Re: A request by Mike Petersen for Preliminary Plat approval for Schutter Farm Addition, a proposed nine (9) lot residential subdivision located in part of the SE ¼ of Section 7, Pleasant Valley Township, north of Valley Drive, west of Spencer Creek and east of Spencer Road.

PLANNING & ZONING COMMISSION
STAFF REPORT
April 5, 2011

PRELIMINARY PLAT OF SCHUTTER FARM ADDITION

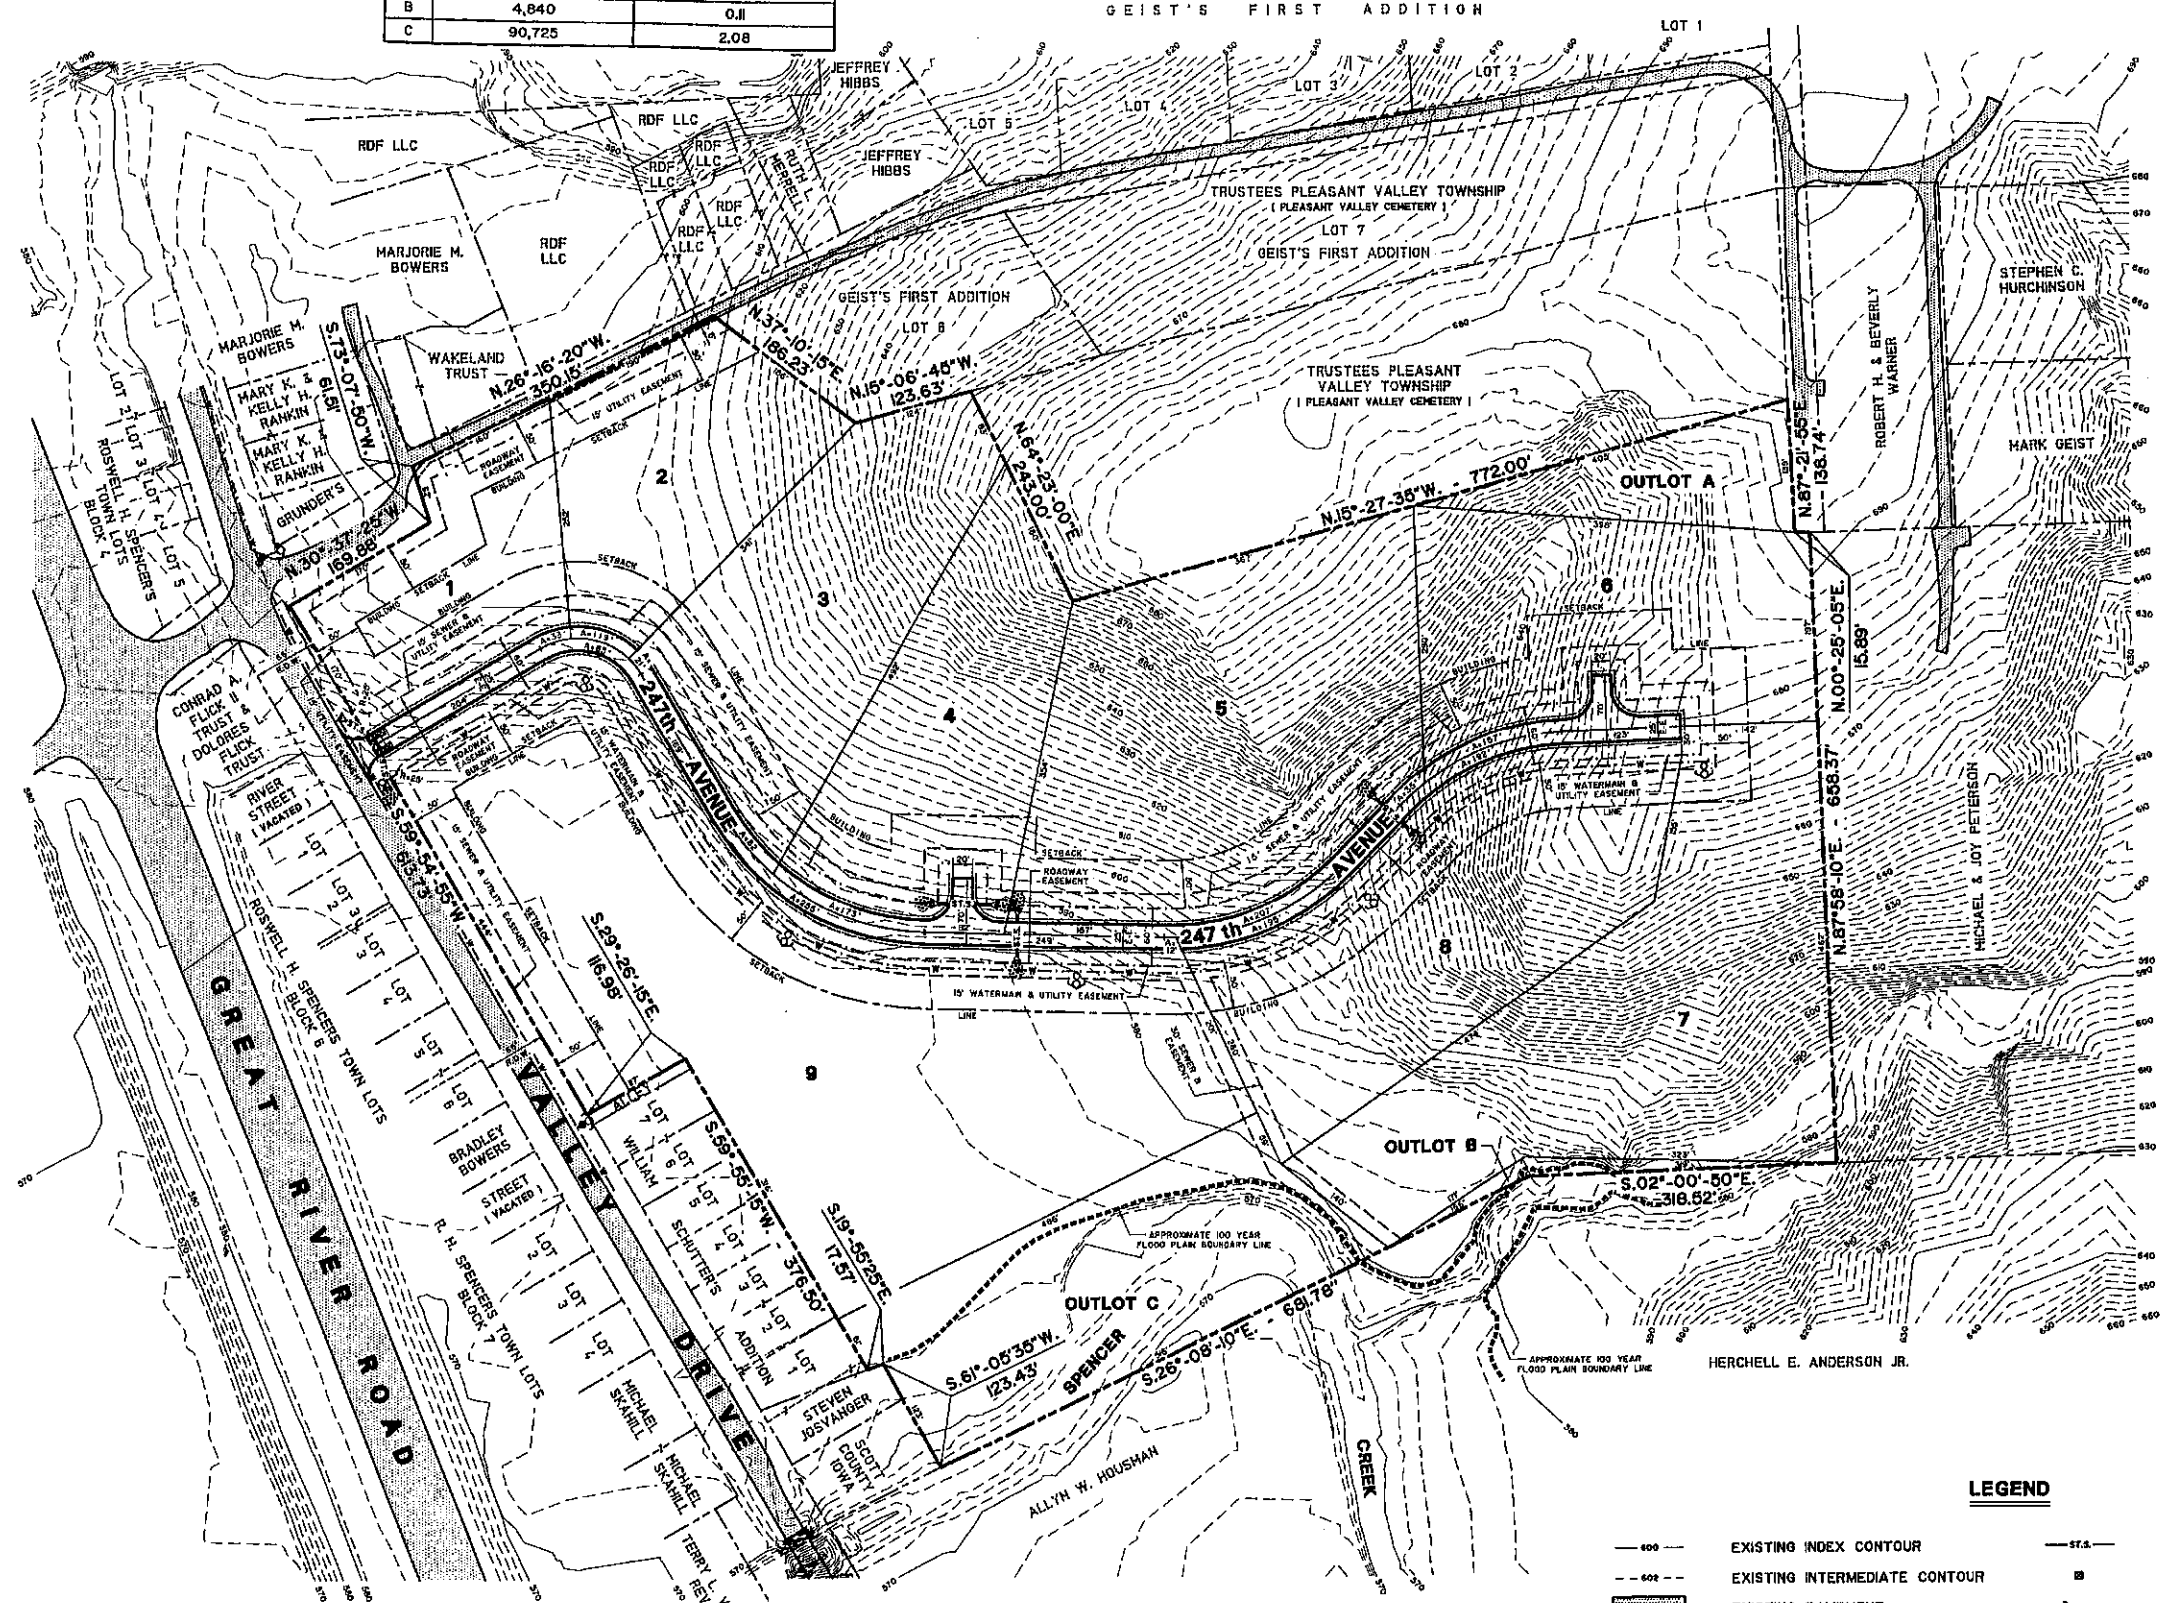
All the lots would be accessed from the proposed interior road which would be a cul de sac approximately 1,550 feet in length with a intermediate turnaround provided halfway into the subdivision and another at the end. Both turnarounds are of a hammerhead design. The maximum length of a cul de sac allowed under the subdivision regulations is ¼ of a mile or 1,320 feet.

The proposed private access road slightly exceeds the maximum length for a dead end street. The Subdivision Regulations do allow the Planning Commission to recommend approval of a modification of the requirements of the ordinance. Staff would believe that the nature of the surrounding development, along with the location of Spencer Creek really create a unique circumstance that would allow approval of this variance to the Subdivision Regulations. The proposed road design would allow the property to be developed in a reasonable manner and the intermediate turnaround provided near the halfway point into the subdivision mitigates concerns with the total length of the road. Furthermore the subdivision is well under the maximum density of thirty (30) lots that are permitted on a dead end road.

All of the proposed nine development lots would have access to an interior road that would end with a hammerhead turnaround. The interior street intersects with Valley Drive in a location determined to be acceptable by the County Engineer. The subdivision ordinance requires this proposed street to be numbered as an avenue in accordance with the County's E-911 addressing regulations.

The Subdivision regulations require all internal streets to be adequately drained and that detention facilities adequate to capture the runoff from a one hundred (100) year rain event shall be placed in the subdivision. The release rate from that detention area shall not exceed the volume produced by a five (5) year event. The stormwater drainage plan and the design of detention facilities are normally completed after Preliminary Plat approval and reviewed and approved prior to Final Plat approval. The County Engineer has discussed with the applicant's engineer a drainage plan that would direct the stormwater directly to Spencer Creek with limited detention that would be acceptable due to this property's proximity to the Mississippi River.

The subdivision regulations require the submission of an erosion and sediment control plan prior to Preliminary Plat approval. A preliminary plan has not been submitted. The applicant's engineer stated that detailed plans would be submitted in conjunction with the road construction plans. Those plans shall include information regarding the soil types, the specifications for temporary and permanent erosion and sedimentation control and the proposed timing schedule and development sequence.

- 1) A variance to the subdivision regulations be approved to allow the length of the private road to exceed 1,320 feet;
- 2). An erosion and sediment control plan be in accordance with the requirements of the Natural Resources Conservation Service and the County Engineer be submitted;
- 3). The proposed wastewater treatment facilities meet Health Department and Iowa Department of Natural Resources requirements;
- 4). The private covenants include provision for private road and common open space maintenance;
- 5). The County Engineer review and approve all street construction plans prior to construction; and
- 6). The subdivision infrastructure improvements be completed or a surety bond posted prior to Final Plat approval.

1. An erosion and sediment control plan be in accordance with the requirements of the Natural Resources Conservation Service and the County Engineer be submitted;
2. The proposed wastewater treatment facilities meet Health Department and Iowa Department of Natural Resources requirements;
3. The private covenants include provision for private road and common open space maintenance;
4. The County Engineer review and approve all street construction plans prior to construction; and
5. The subdivision infrastructure improvements be completed or a surety bond posted prior to Final Plat approval.
